NEDO-20566-1-A  
REVISION 1  
77NED304  
CLASS I  
OCTOBER 1982

**GENERAL ELECTRIC COMPANY ANALYTICAL  
MODEL FOR LOSS-OF-COOLANT ANALYSIS  
IN ACCORDANCE WITH 10CFR50 APPENDIX K  
AMENDMENT NO. 1 —  
CALCULATION OF LOW FLOW FILM BOILING  
HEAT TRANSFER FOR BWR LOCA ANALYSIS**

SUBJECT: ACCEPTANCE FOR REFERENCING OF TOPICAL REPORT NEDE-20566P,  
NEDE-20566-1 REVISION 1 AND NEDE-20566-4 REVISION 4

Report No.: NEDO-20566-1, Revision 1

Figure C-6. Deduced Heat Transfer Coefficient vs Modified Bromley Correlation

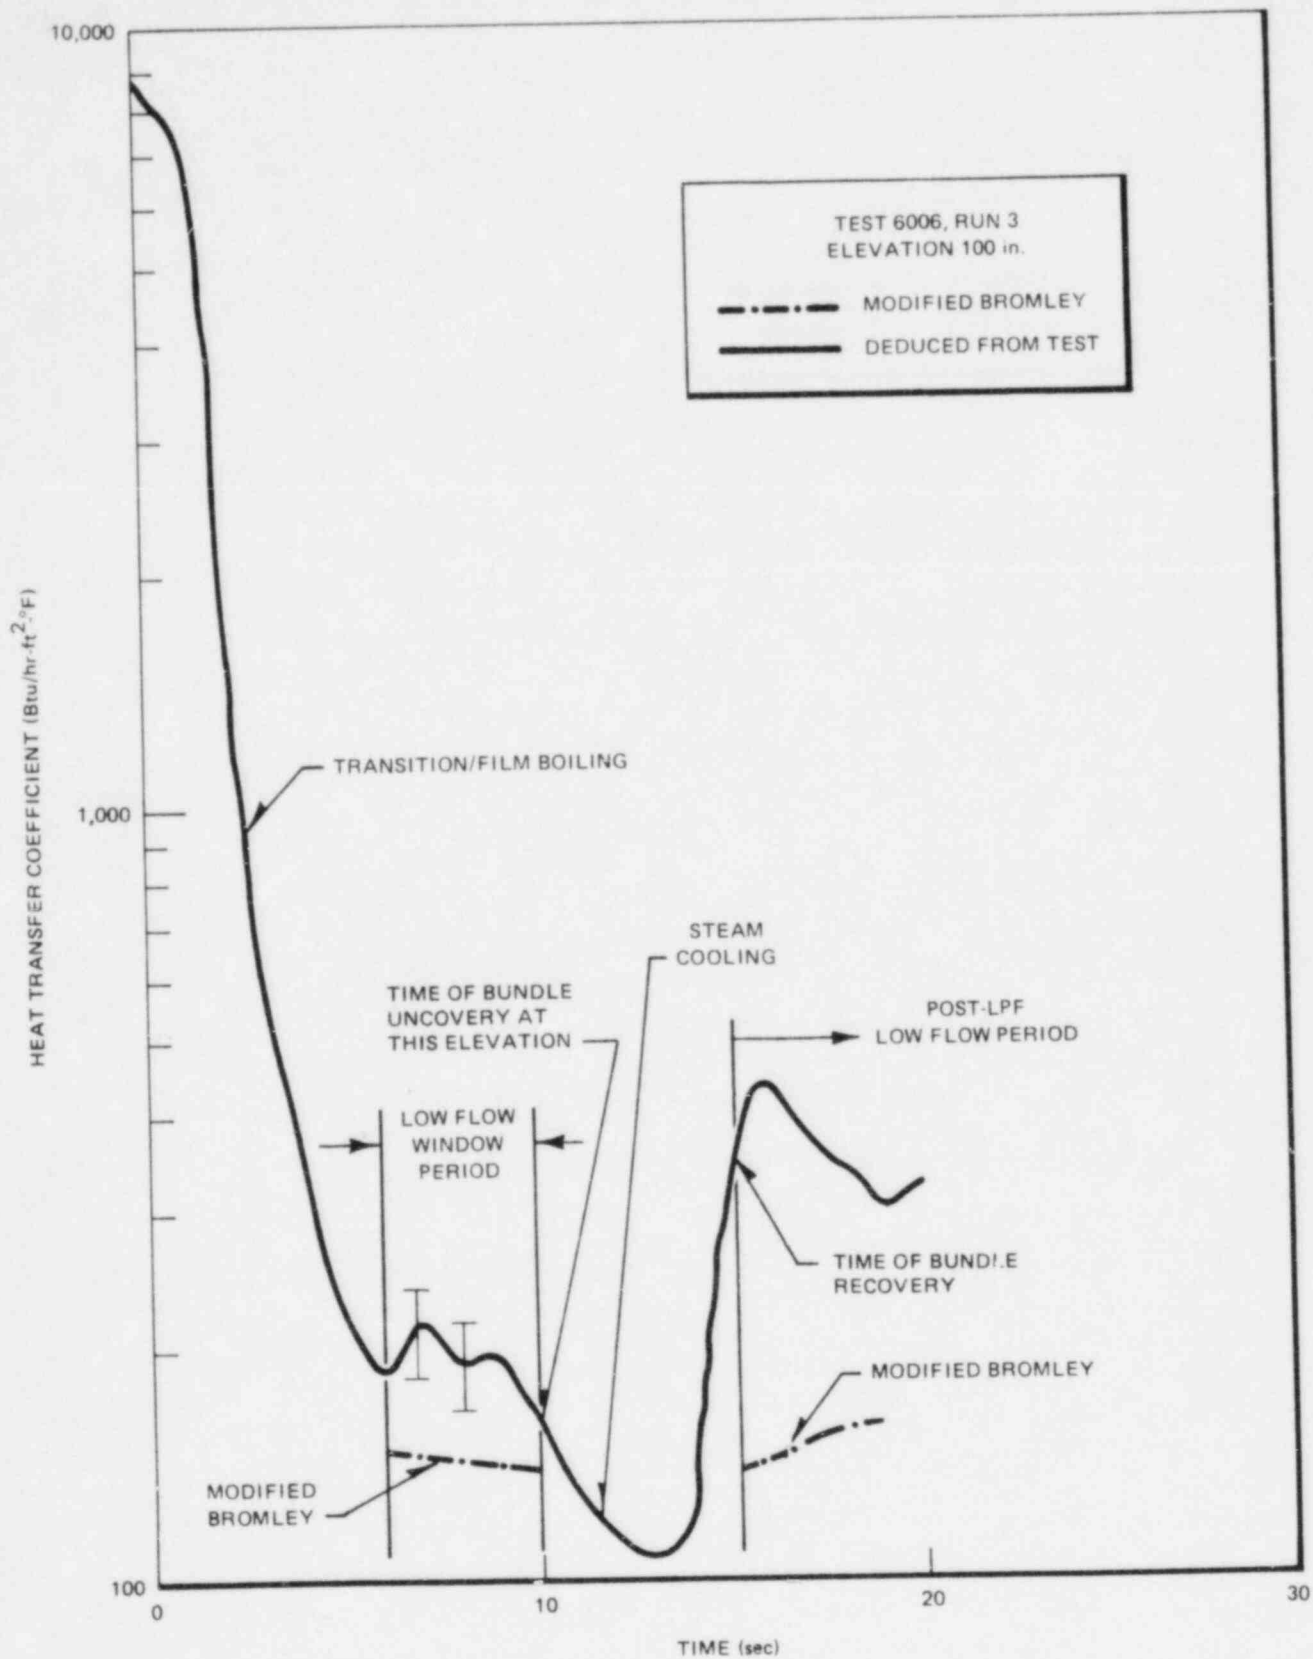
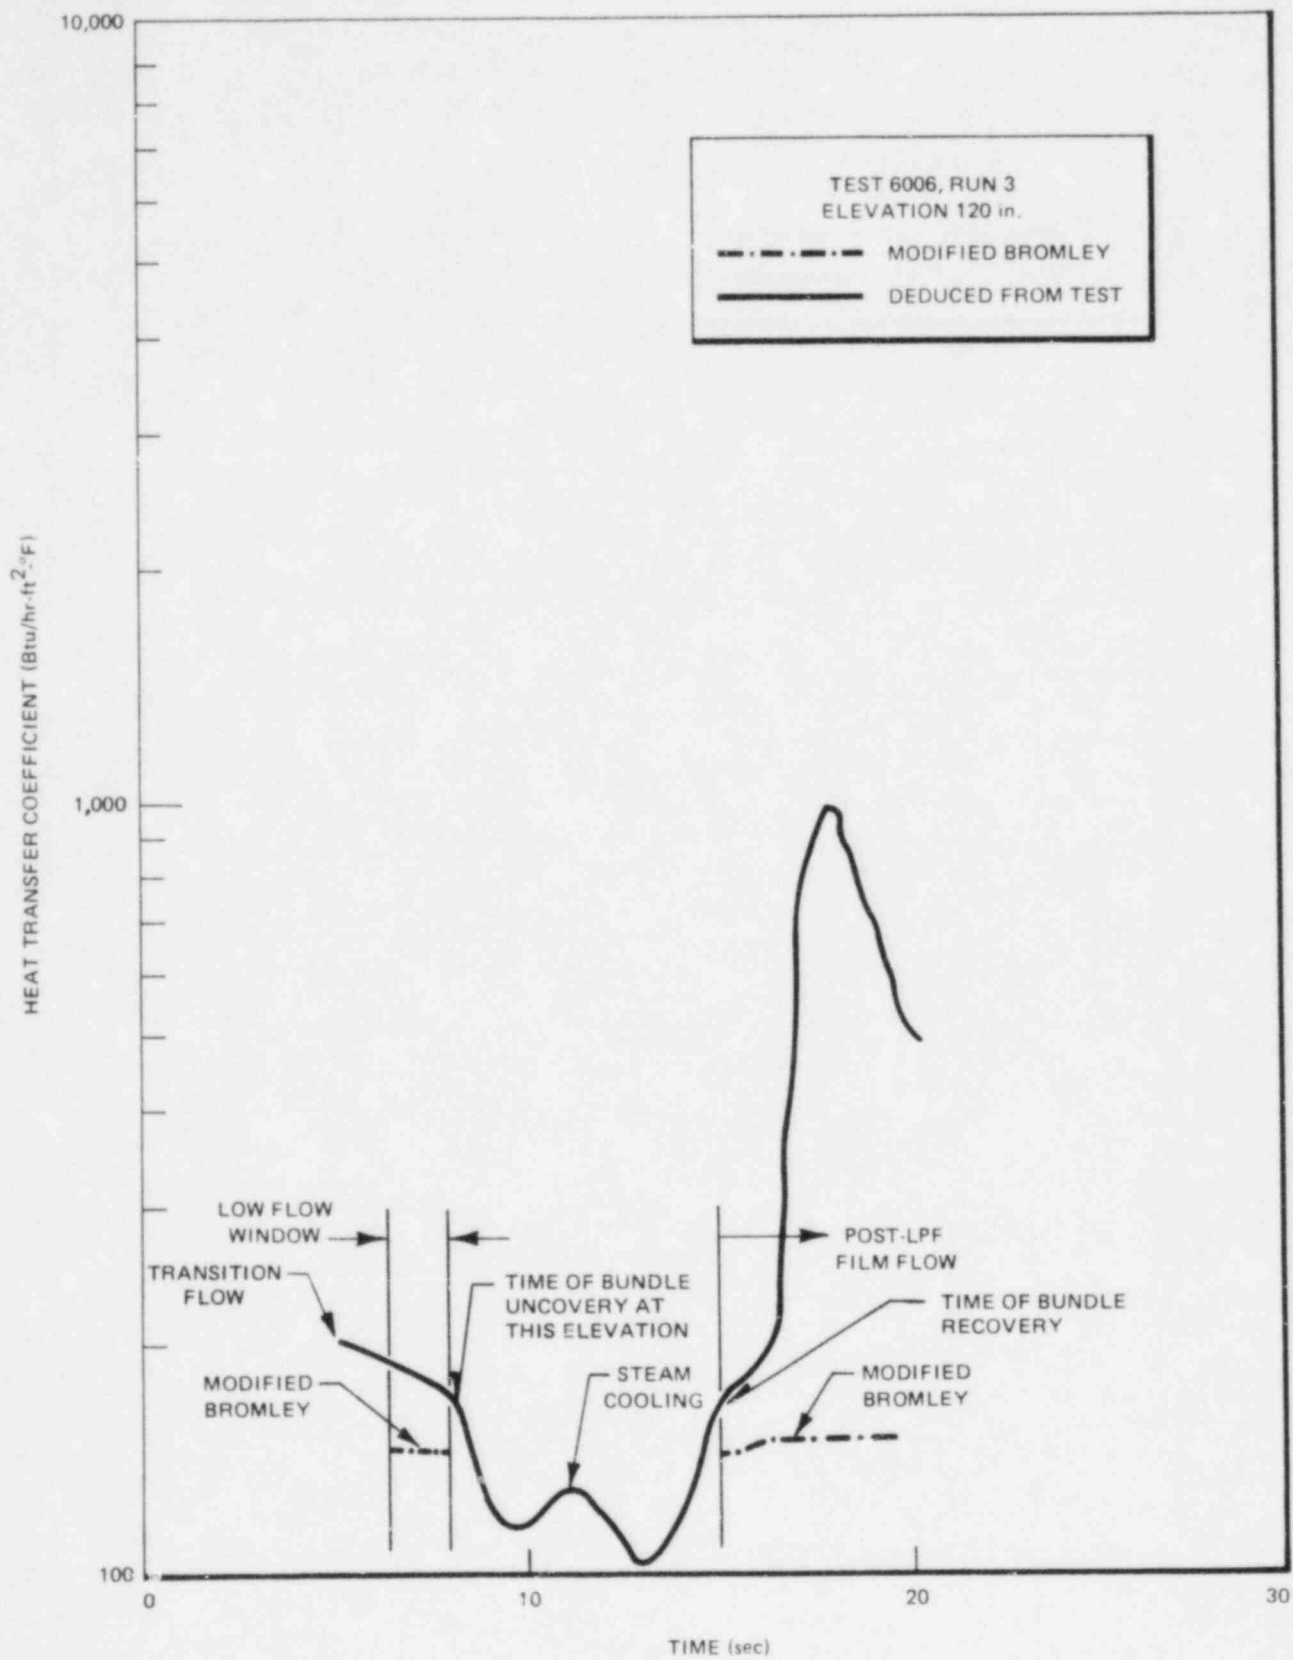
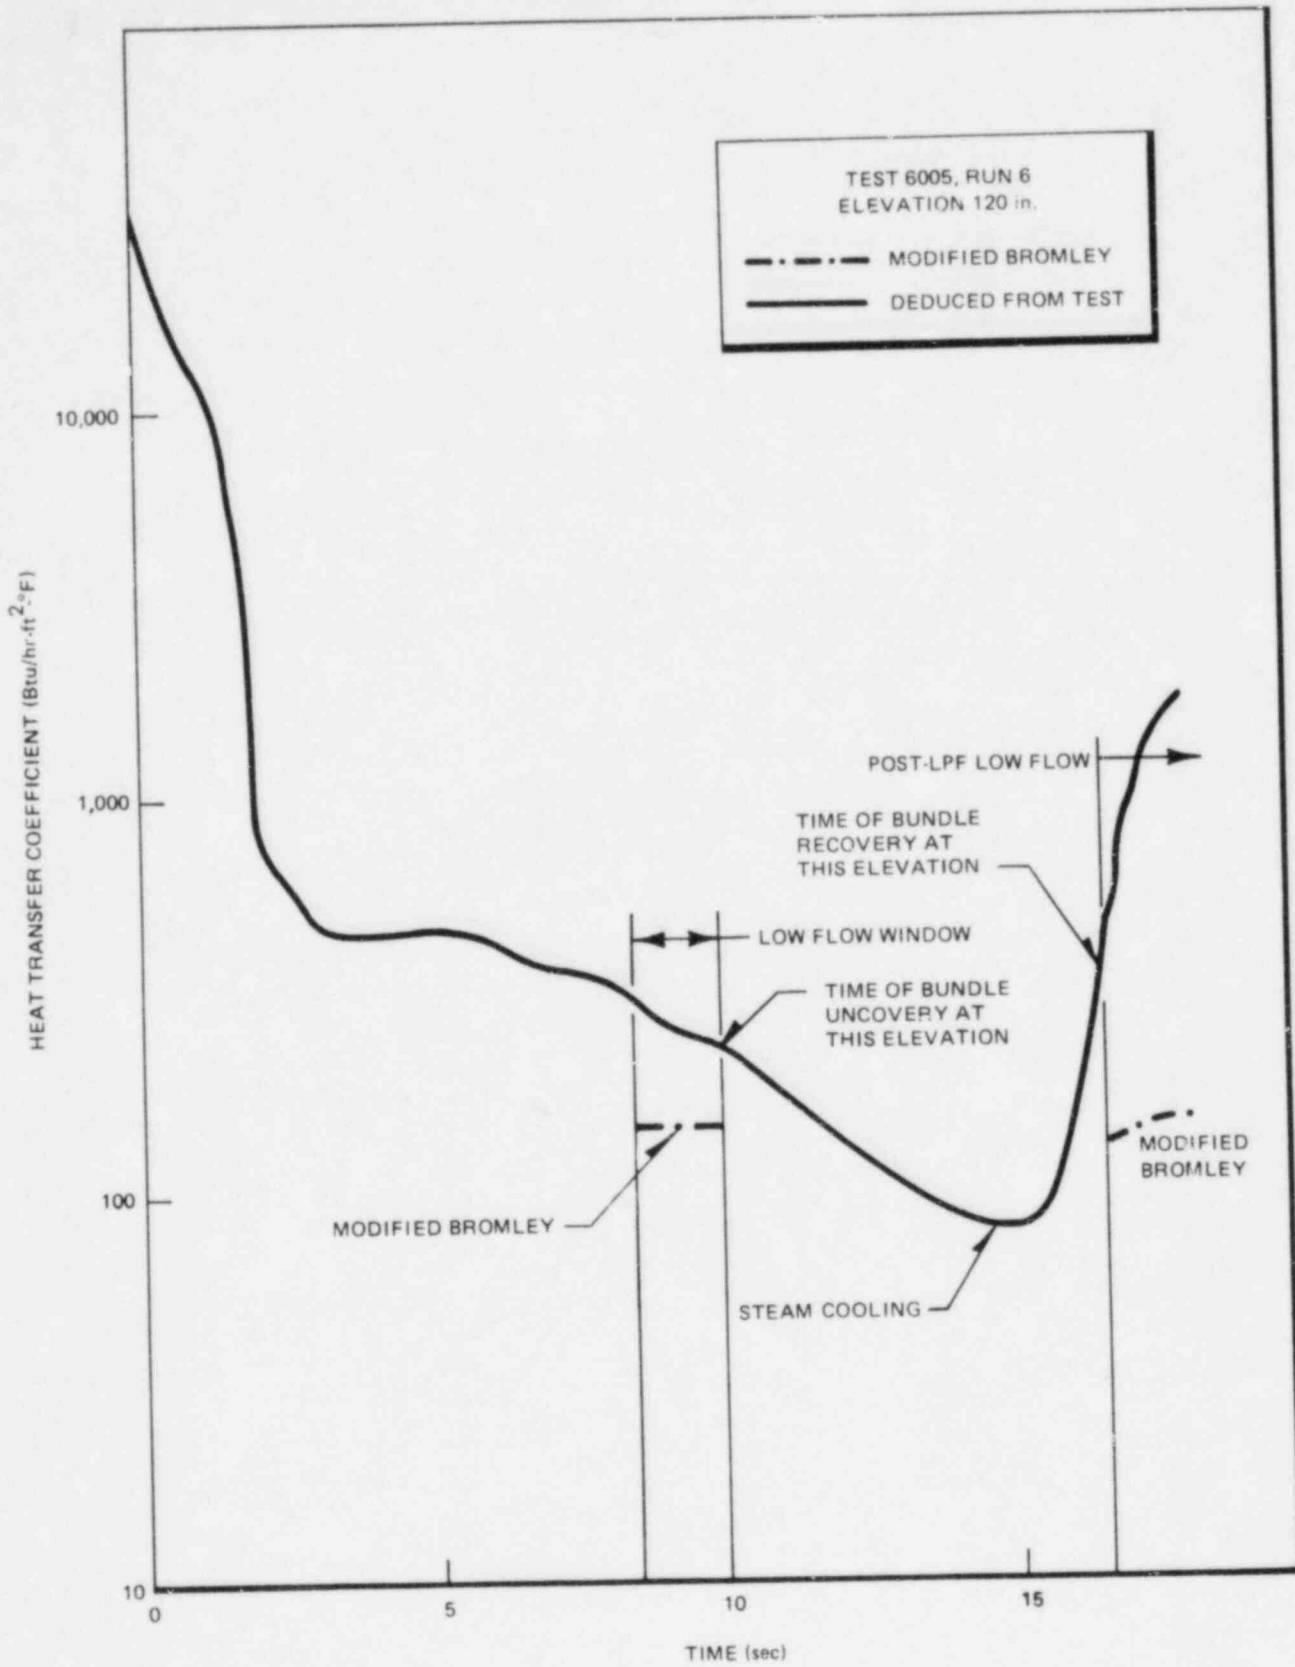
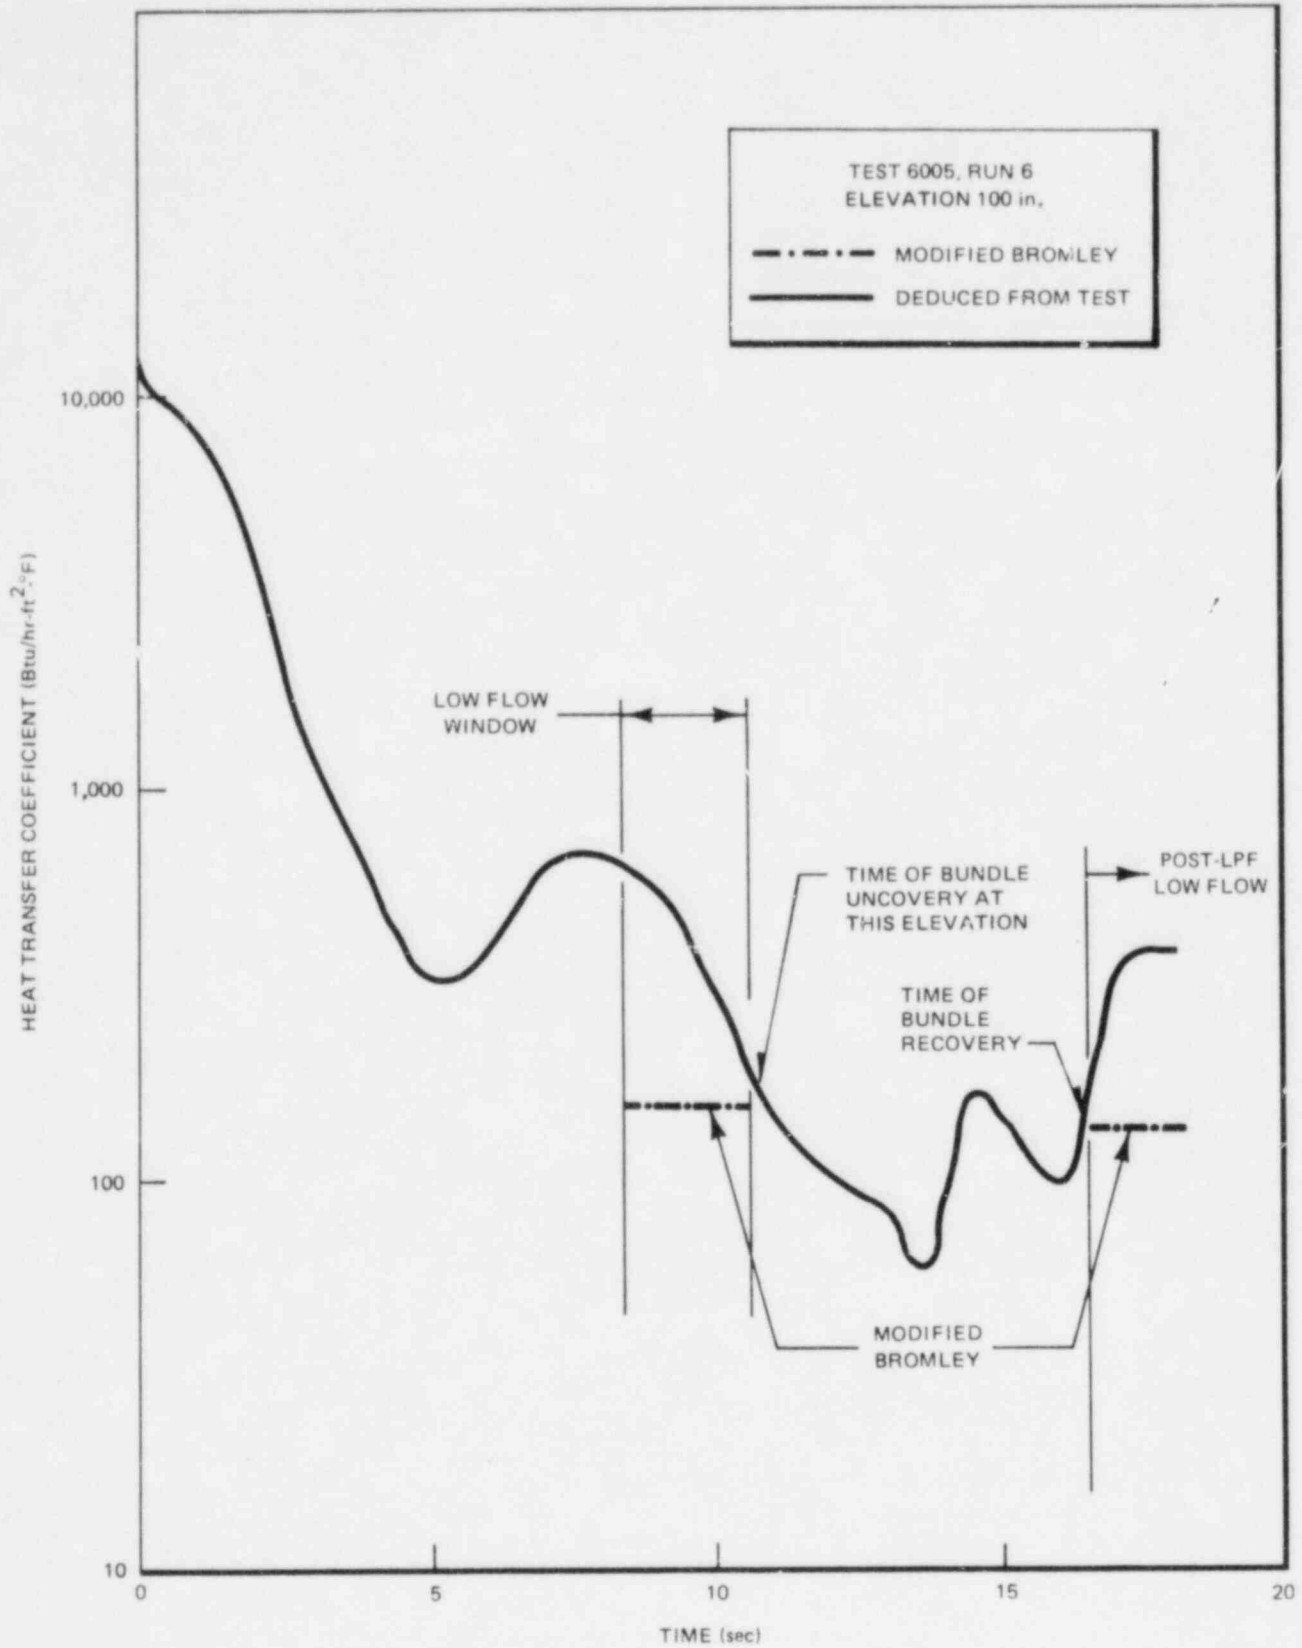
Question 2: Compare the Modified Bromley correlation to appropriate portions of data from the BDHI program with 8x8 fuel bundles; include tests from the BD/ECC program in the comparison. The purpose of this request is to extend the data base supporting Modified Bromley to 8x8 fuel design and to the early portion of the reflood transient.

Figures C-6 and C-7 show comparisons of reduction test data with the correlation at two elevations, 199 and 200 inches above the bottom of the heated length (BHL), for Test 6006 Run 3. The corresponding two-phase mixture level and coastdown core flow are shown in Figure C-7. Figures C-5, C-8, and C-9 present comparisons for Test 6005 Run 6 at elevations 120 and 100 inches above the BHL.

The periods of interest for low flow comparisons are indicated on the figures. This comparison of Modified Bromley and experimental heat transfer coefficients from the 8x8 bundle shows the same results as previously reported for the 7x7 bundle in NEDO-20566-1. Therefore, the Modified Bromley provides a low-bound estimate of the heat transfer for both the 7x7 and 8x8 bundles.
